**Revised Quarry Restoration Scheme Incorporating
Tunnel Arisings from the Haweswater Aqueduct
Resilience Programme (HARP) Namely the
Bowland and Marl Hill Tunnel Sections.**

Planning Application LCC/2021/0015

Waddington Fell Quarry

Supplemental Submission

Drawing 300461-001 Rev A

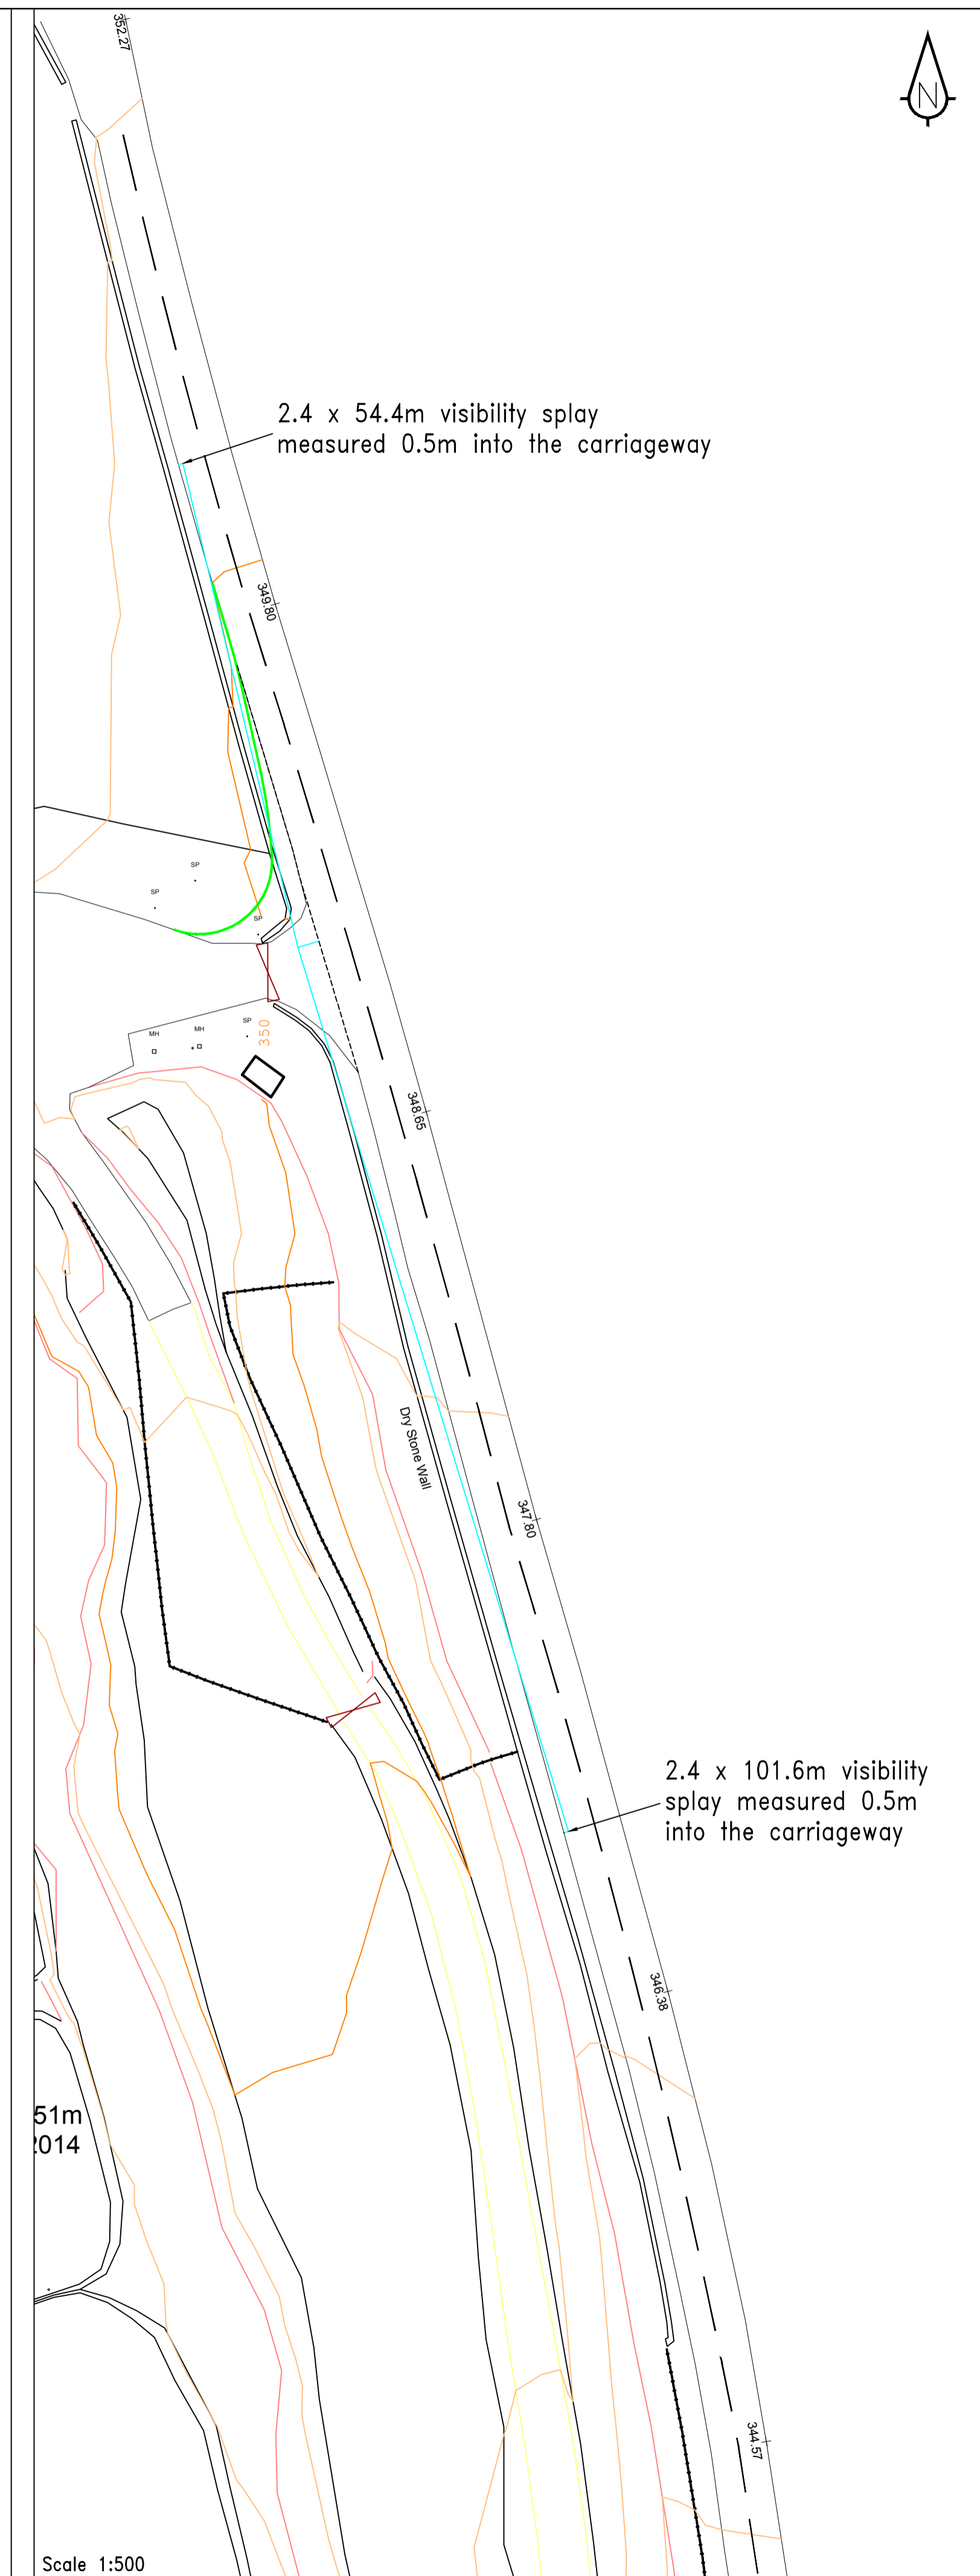
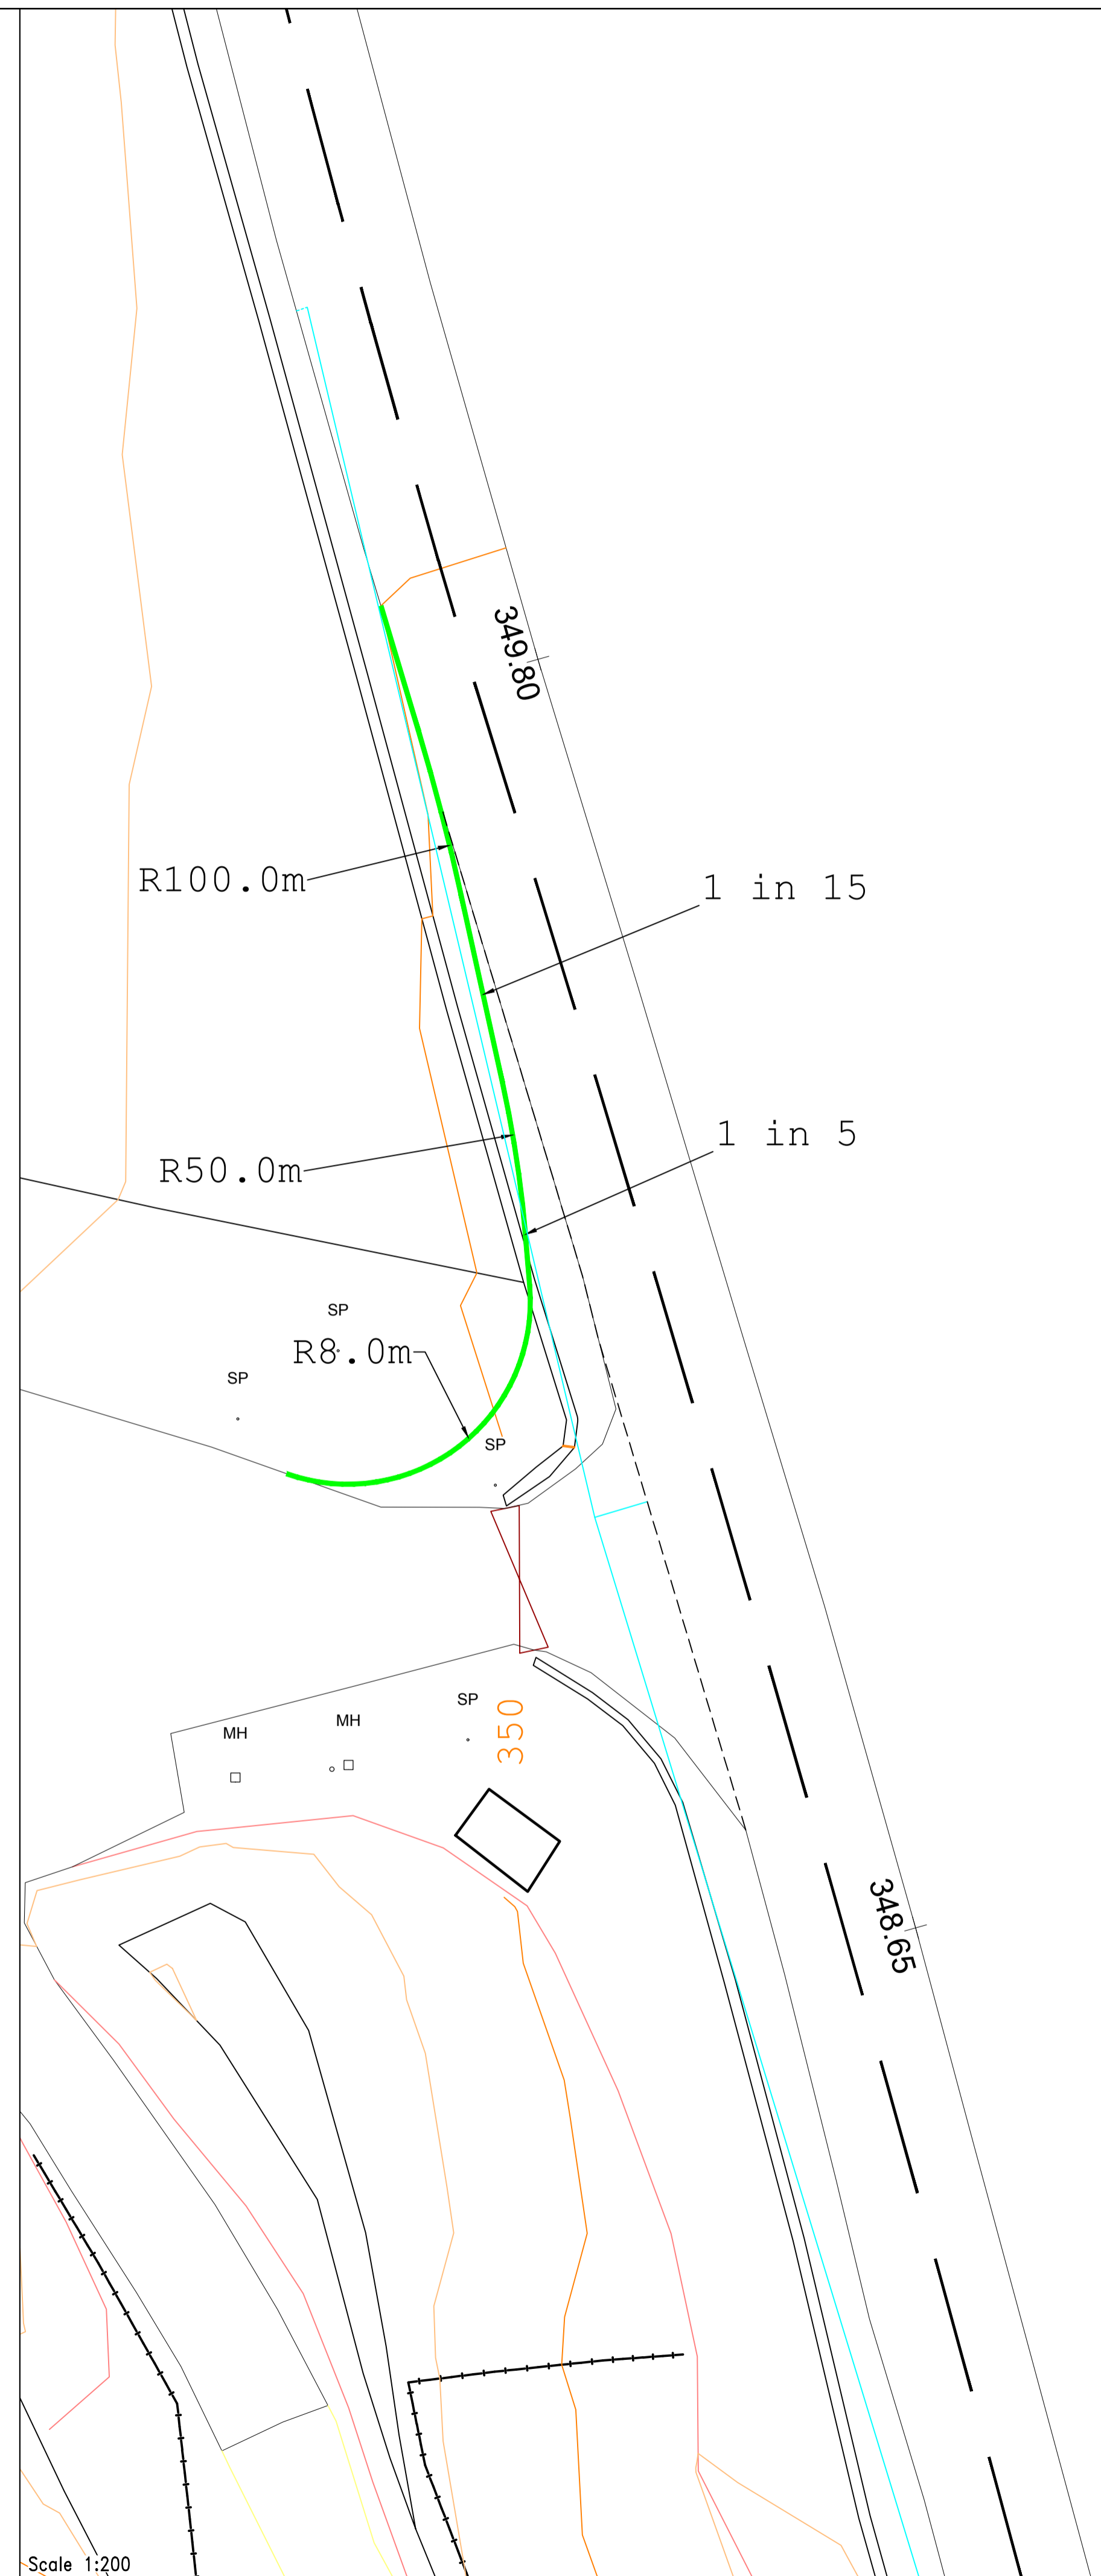
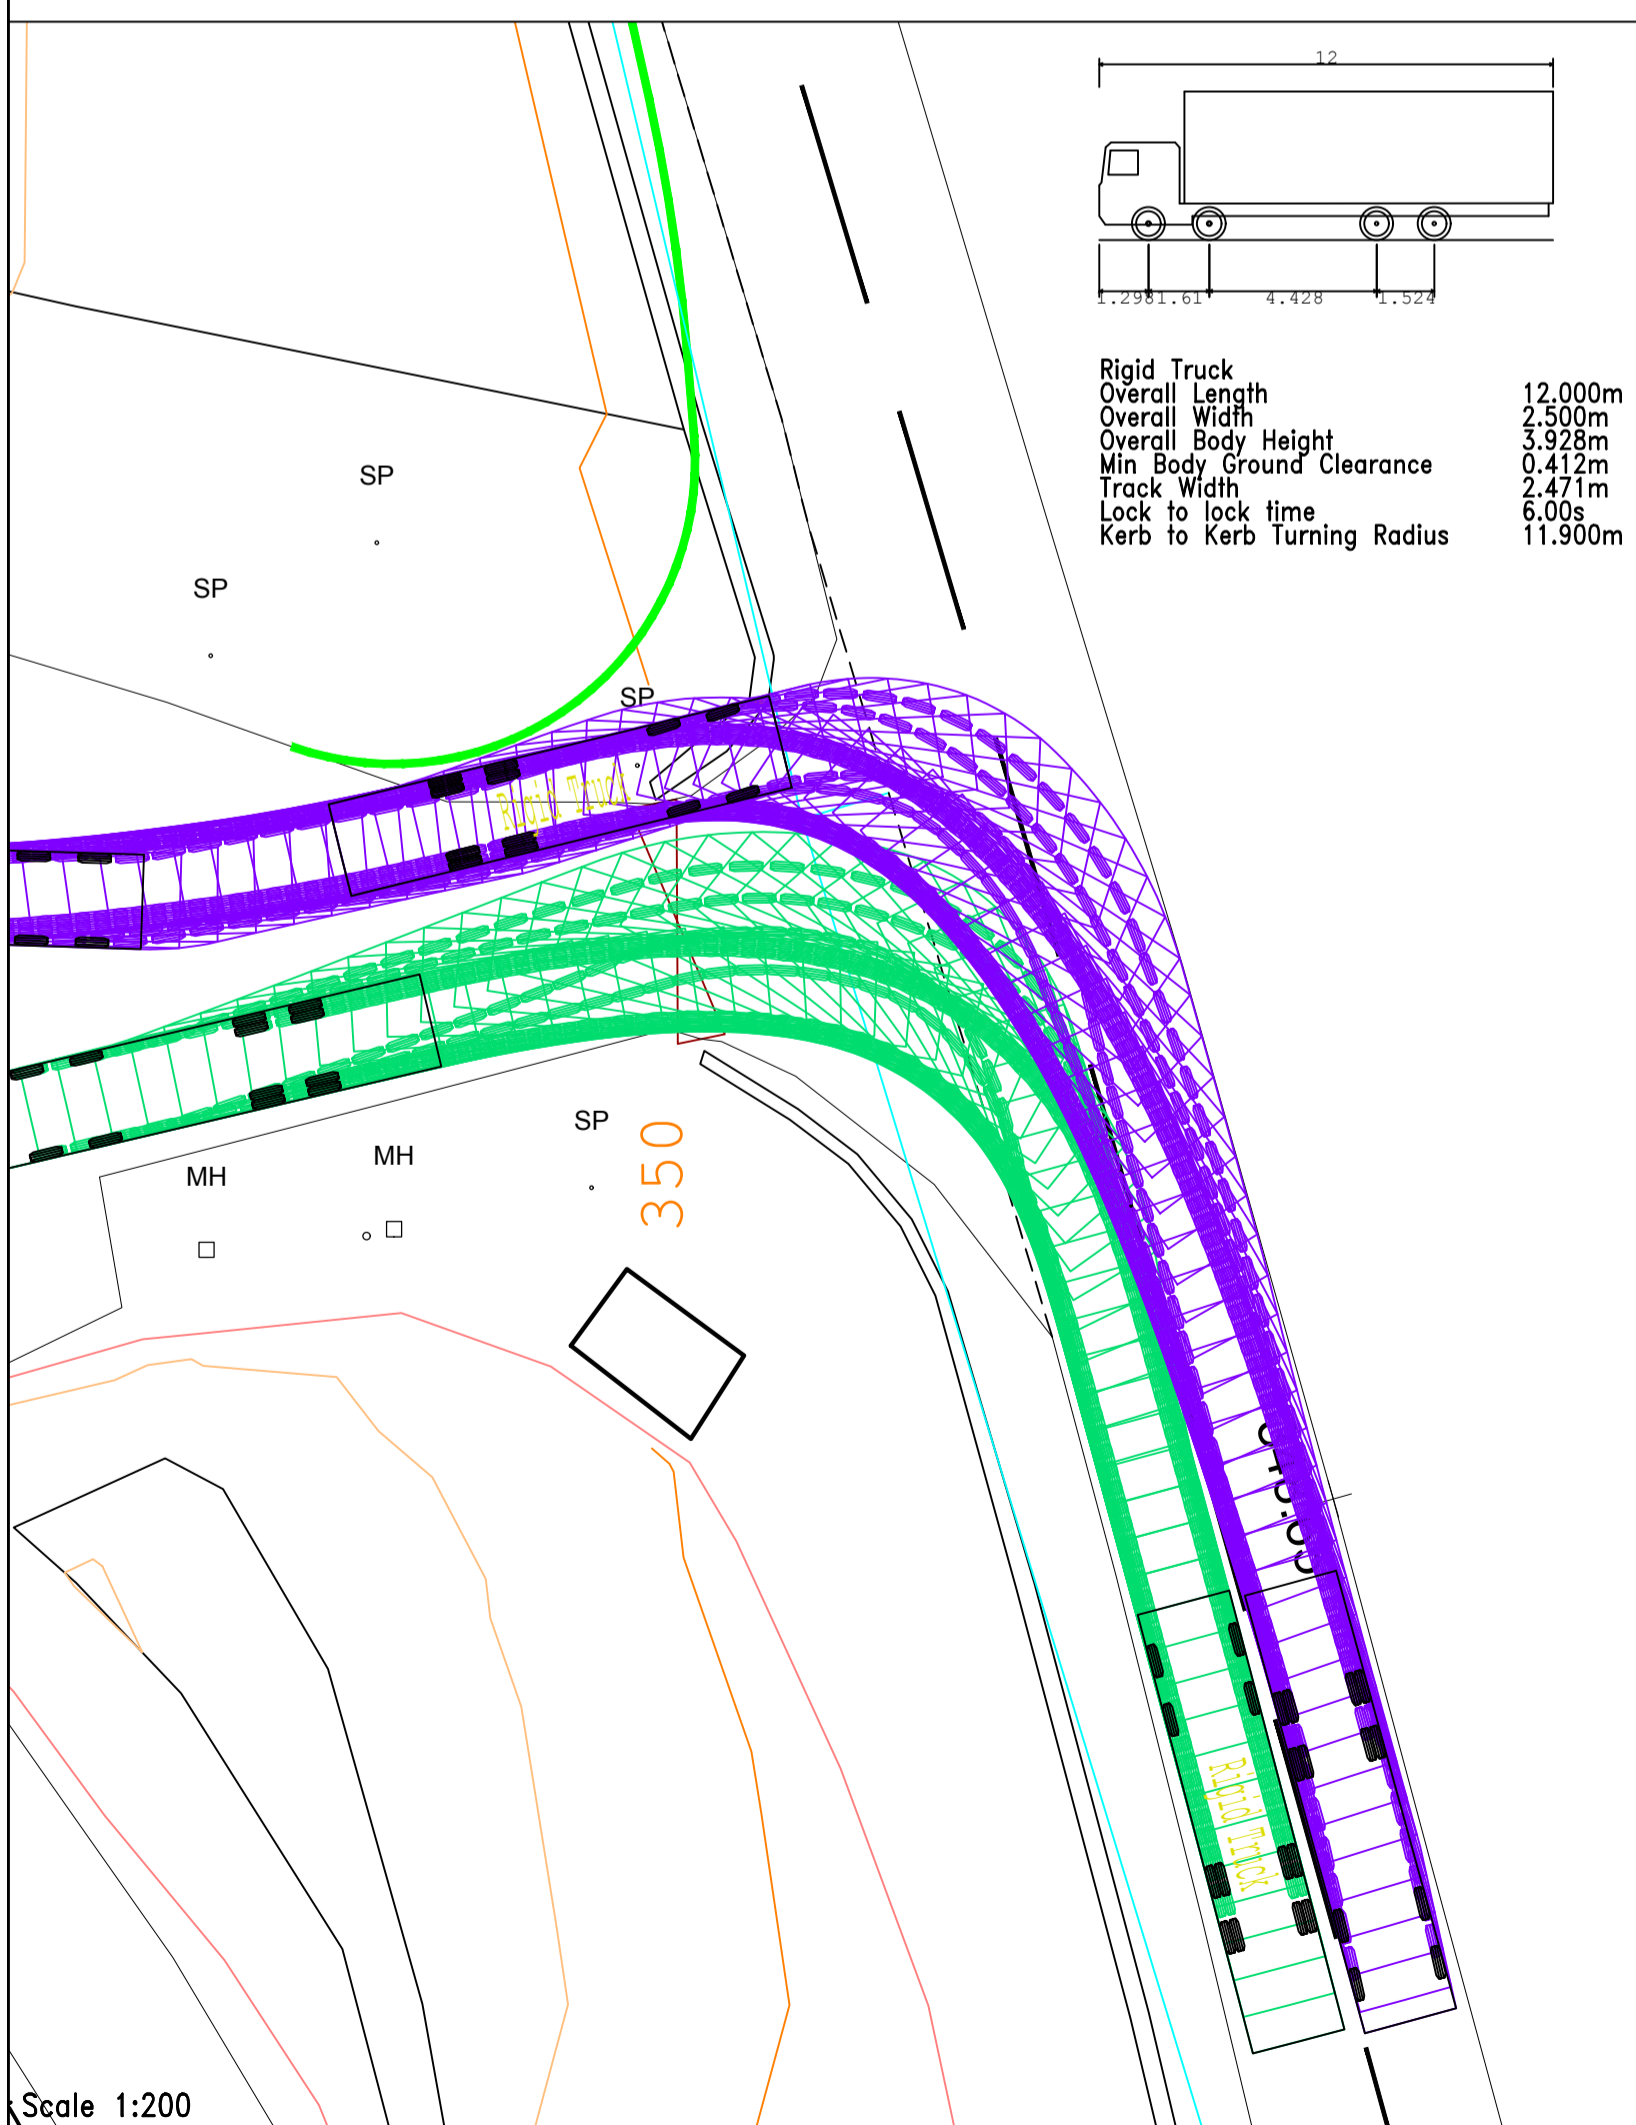
1. *The existing access arrangements are not adequate for the proposal, that will see significant HGV movements to and from the north. Our initial review of ordnance survey maps suggests that the layout, turning radii and width of the existing access cannot accommodate HGV movements in and out of the Quarry simultaneously. These movements must be accommodated to ensure that HGVs are not waiting on the carriageway to access the Quarry, especially during the simultaneous tunnel bores. An improvement scheme at the access, widening the Quarry entrance and improving turning radii to the north is necessary. When the improvement scheme is developed, we would expect to see the site access layout with the swept path analysis and visibility splays.*

Drawing 300461-001 Rev A at **Appendix A** illustrates a preliminary 2D design and includes swept path analysis of a 12m rigid vehicle accessing and egressing the junction in both directions. The drawing demonstrates that vehicles would not need to wait within the highway to access the site.

Drawing 300461-001 Rev A shows that the required stopping sight distances can be achieved from the centre of the proposed site access from an x-distance of 2.4m.
